DEVELOPMENT REVIEW COMMITTEE (DRC) COMMENT REPORT

MEETING DATE: December 11, 2018

PROJECT NAME: Village View

REQUEST: Site Plan Level II Review: 100 Multifamily Affordable Residential Units in Downtown

Existing Stormwater Asset Map possibly affected by the Proposed Development

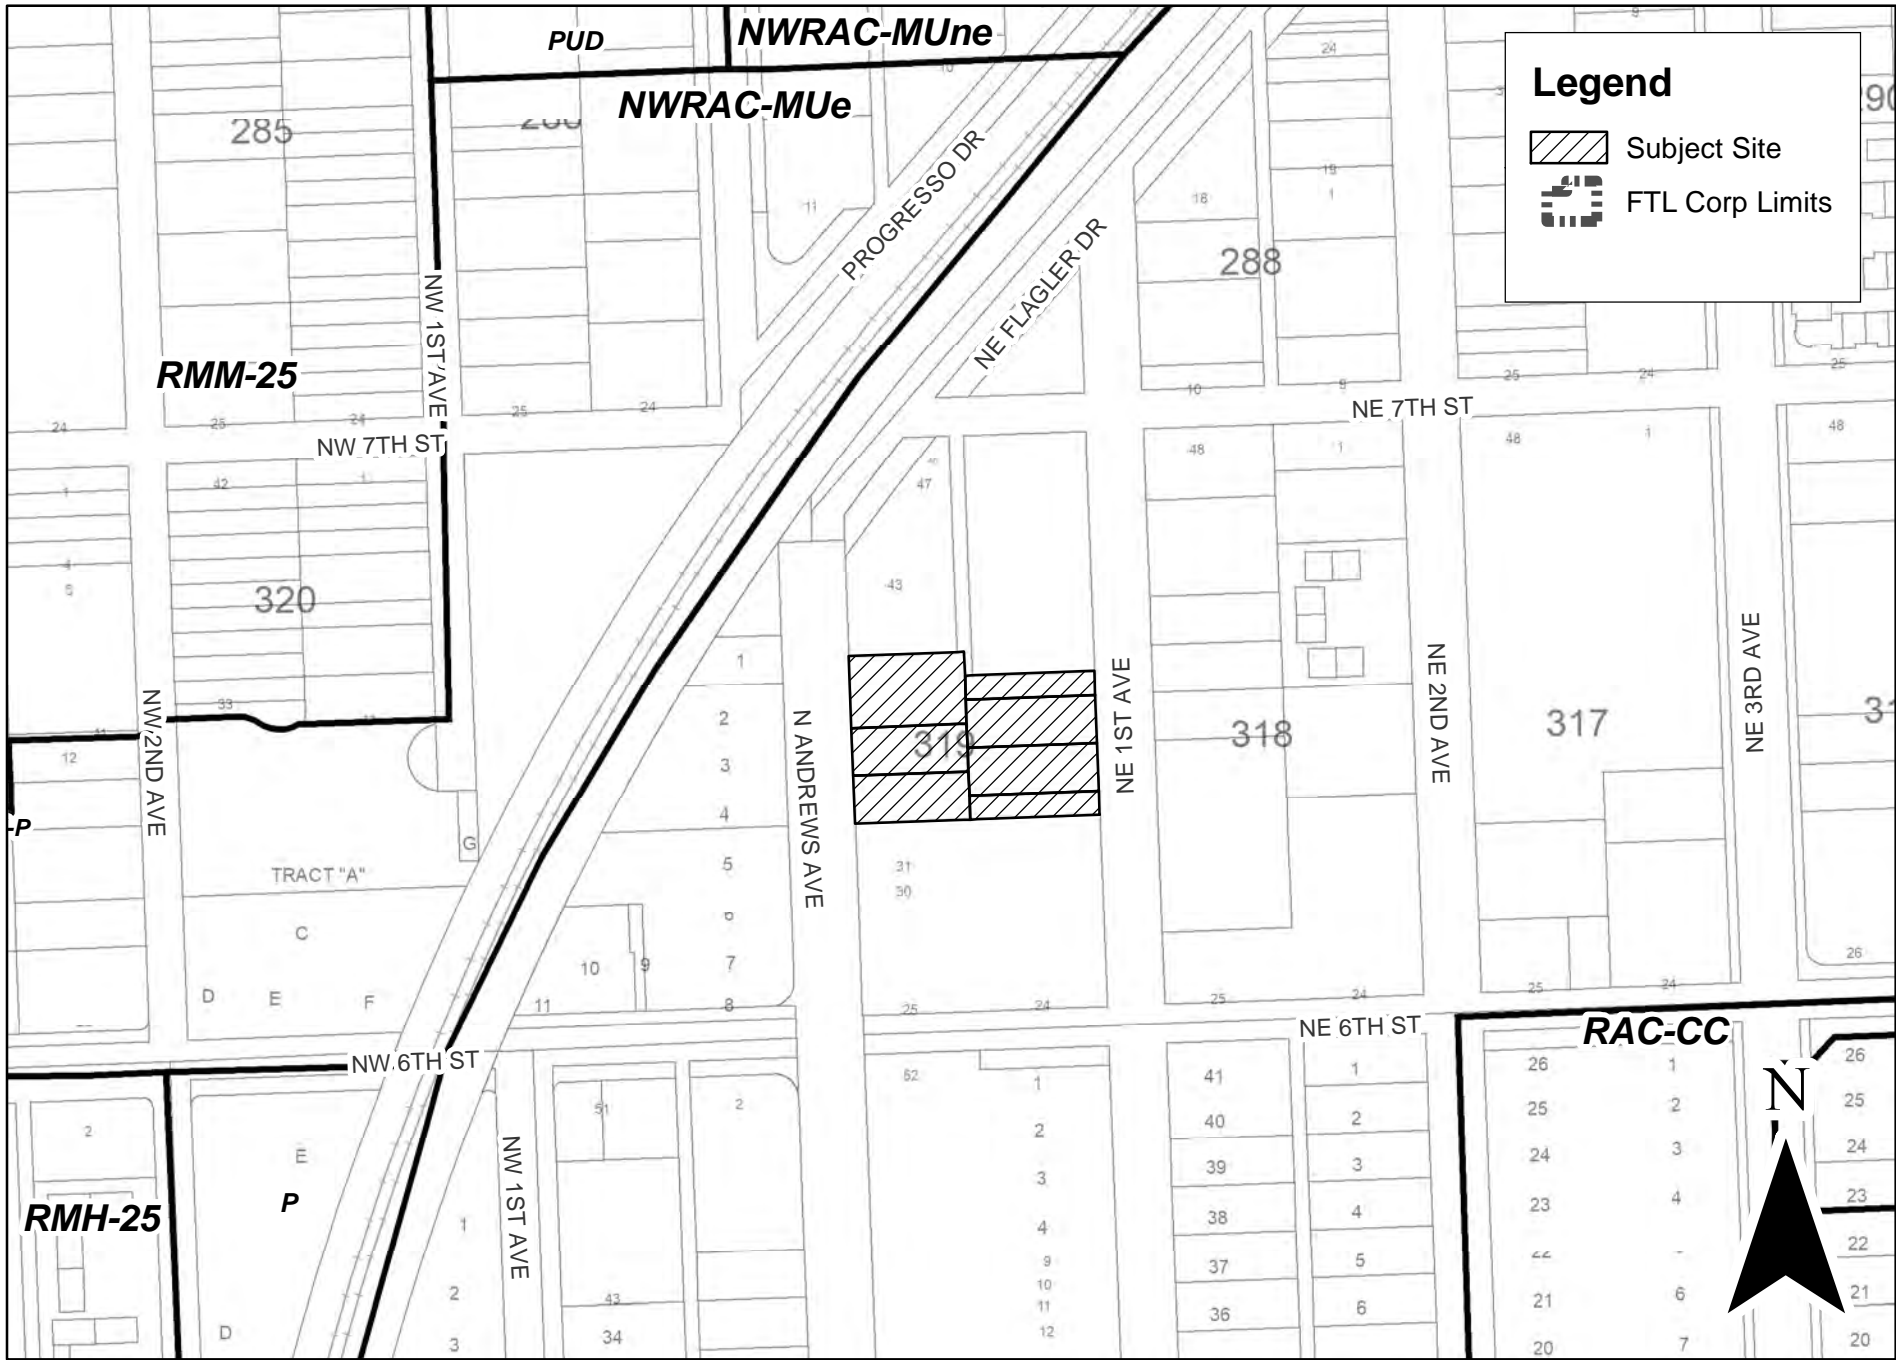
The City owns and maintains stormwater infrastructure adjacent to the proposed development as shown with green line work in the map provided at the end of this report. The following comments pertain to possible impacts of the proposed development and/or construction activities to the existing condition of the City's stormwater assets. The applicant shall provide an itemized response letter addressing the following comments:

1. A topographic survey of the site and adjacent City ROW was not found in the electronic DRC set to evaluate impacts to existing City ROW stormwater assets. Please provide for next submittal.

2. Please email CRBARRETT@FORTLAUDEDALE.GOV to obtain copies of the City utility maps as applicable to the project location and show existing City utilities and easements (water, sewer, forcemain, and stormwater utilities) in proposed engineering plans (utility demolition, stormwater pollution prevention plan (SWPPP), and civil plans).

3. Please note that private stormwater infrastructure (drainage pipes, wells, or basins,) or Permanent Structures (fences, walls, etc.) are not permitted in City Right of Way (ROW), Alleyway, or City drainage easements or cause an adverse stormwater impact to these areas. It is not clear how the proposed site could affect the drainage of the Alleyway (or City R/W per Broward County Property Appraiser Map) located to the north of the proposed development. Please remove any proposed stormwater systems, or permanent structures that are not in compliance with this requirement or provide appropriate documentation of City Rights-of-Way or easement vacated to allow the construction of private underground utilities.

4. The edge of any City's existing stormwater assets (pipes, exfiltration trenches, structures, or other) shall be at 5' minimum (7' preferred) horizontal clearance from any proposed tree's root system and with appropriate root barriers per City's landscaping regulations. This applies to the proposed trees and exfiltration system on NW 1st Ave.

5. Proposed C&G or other surface features in City ROW handling stormwater runoff & connecting to adjacent City's Drainage surface assets (such as other curbs, swales, etc.) shall be shown with sufficient grade elevations and transitions details on civil plans to demonstrate that the proposed roadway improvements are not creating drainage puddles in City's roadways. This applies to NW 1 Ave.
